Form 3160-5 (August 2007)

14. I hereby certify that the foregoing is true and correct Name (Printed/T	Typed)						
Dollie L. Busse	ory Technician						
Signature Date 8/7/12							
THIS SPACE F	OR FEDE	RAL OR ST	ATE OFF	ICE USE			
Approved by Original Signed: Stephen Mason			Title		AUG 1 4 2012 Date		
Conditions of approval, if any, are attached. Approval of this notice does net that the applicant holds legal or equitable title to those rights in the subject entitle the applicant to conduct operations thereon			Office

ConocoPhillips SAN JUAN 30-6 UNIT 488S Expense - P&A

Re: Permanent Abandonment Well: 488S San Juan 30-6 Unit

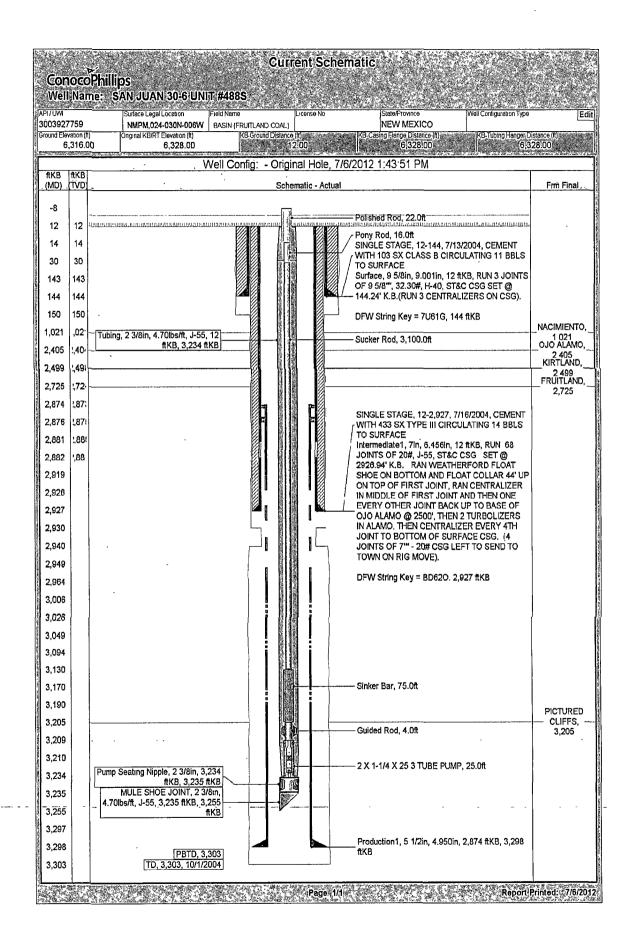
- 1. Plugging operations authorized are subject to the attached "General Requirements for Permanent Abandonment of Wells on Federal and Indian Lease."
- 2. Farmington Office is to be notified at least 24 hours before the plugging operations commence (505) 564-7750.
- 3. The following modifications to your plugging program are to be made:
- a) Place the Kirtland/Ojo Alamo plug from 2542' 2216'.
- b) Place the Nacimiento plug from 1046' 946'.
